Explosive atmospheres – Part 11: Equipment protection by intrinsic safety "i"

INTERPRETATION SHEET 1

Draft Interpretation Sheet Annex G

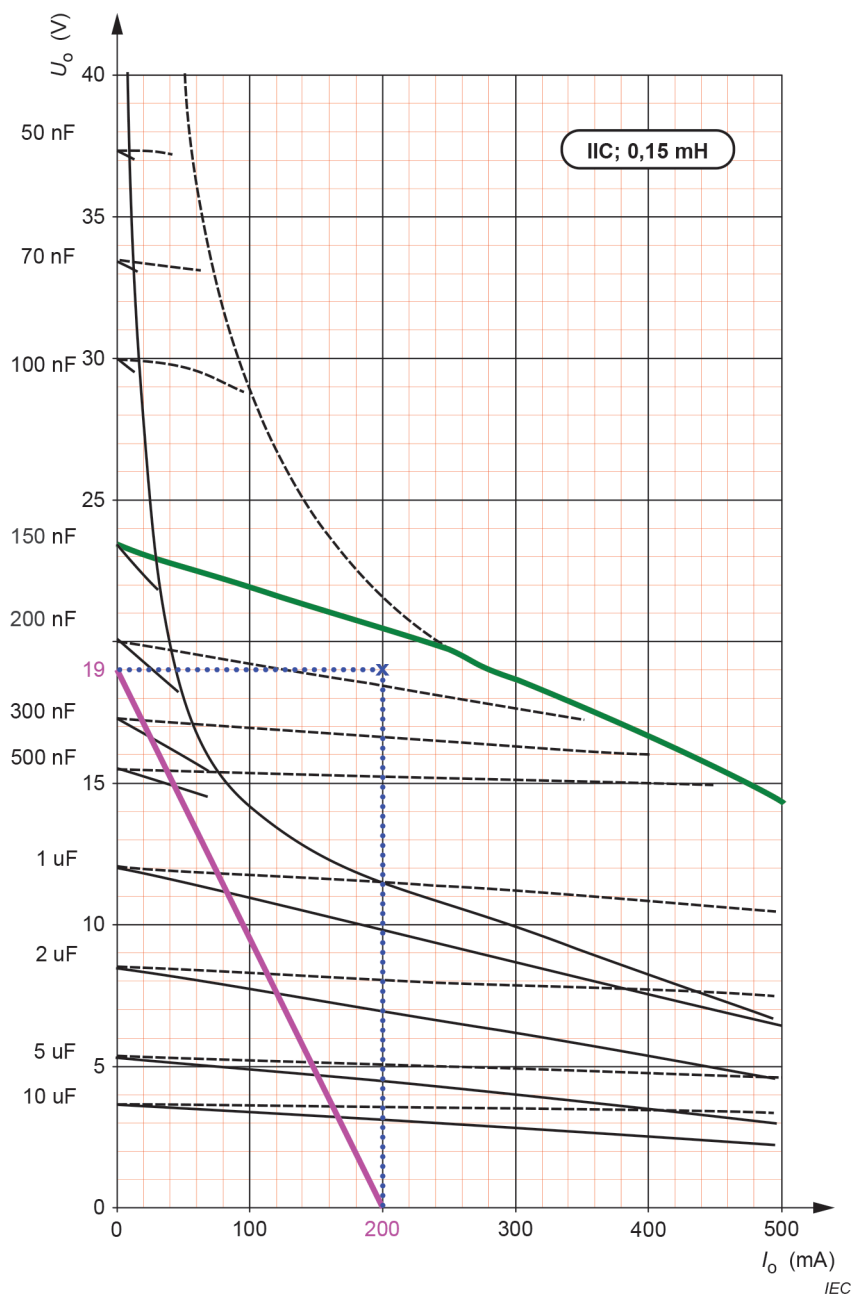
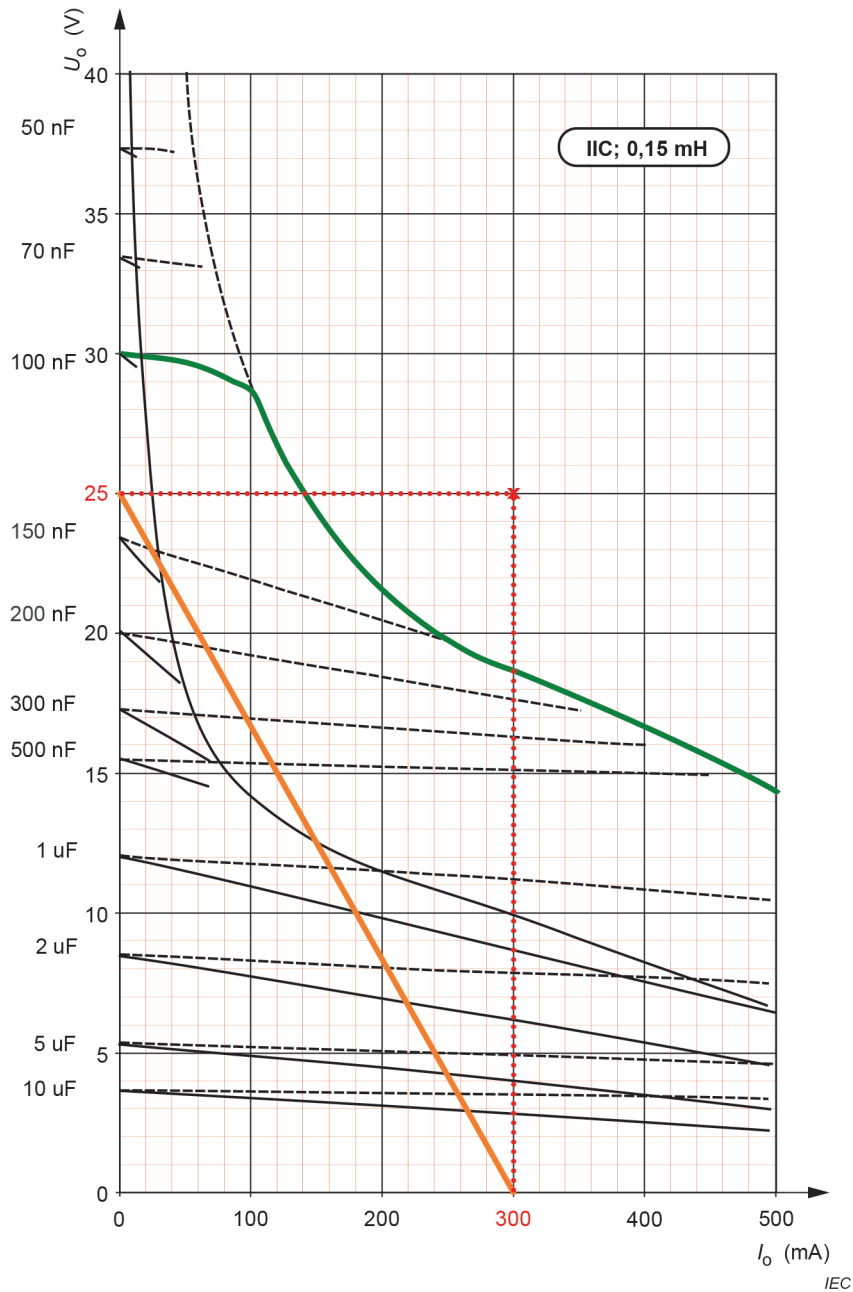
However, the clause does not state the corresponding current at which the maximum voltage of the linear source should be drawn in the applicable diagram.

What is the correct point to apply diagrams from Figure G.2 or Figure G.3 for linear sources?

The point on the applicable diagram where the maximum voltage shall be compared with the limit curve for linear sources is the point representing the maximum voltage and maximum current. This is equivalent to Clause G.3, item b).

Example 1 The pink line shows a linear source with $U_o = 19$ V and $I_o = 200$ mA.

The point representing the maximum voltage and maximum current is derived from the dotted blue line.

The solid green line represents the capacitive and inductive limit for a linear source for $L_o = 0,15$ mH and $C_o = 150$ nF.

The intersecting point representing the maximum voltage and current of the linear source is below the green line and would be acceptable. This meets Clause G.3, item b).

The proposed allowed capacitance for IIC of $C_o = 150$ nF is below the value of 258 nF allowed for a maximum voltage of 19 V in Table A.2 in IEC 60079-11:2023.

Example 2 The orange line shows a linear source with $U_o = 25$ V and $I_o = 300$ mA.

The point representing the maximum voltage and current is derived from the dotted red line.

The solid green line represents the capacitive and inductive limit for a linear source for $L_o = 0,15$ mH and $C_o = 100$ nF.

It can be seen that the intersecting point representing the maximum voltage and current of the linear source (shown in red) is above the green line and would not be acceptable. This does not meet Clause G.3, item b).
